16. COA-048381-2019

14 1/2 West Leigh Street

Commission of
Architectural Review

STAFF REPORT

Figure 1. Sanborn Map, 1905.

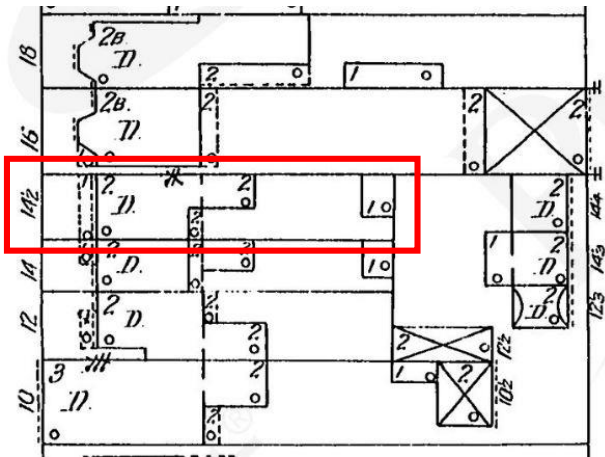
The applicant proposes to remove a section at the rear of the building. Staff has found Sanborn maps dating from 1905-1952 that show a rear two-story addition and staff believes that if this section is not original to the building it has gained significance in its right. Staff recommends denial of the demolition of the rear section. Staff also notes the plans do not show an existing second story door and staff requests the applicant provide revised elevations that account for this opening.
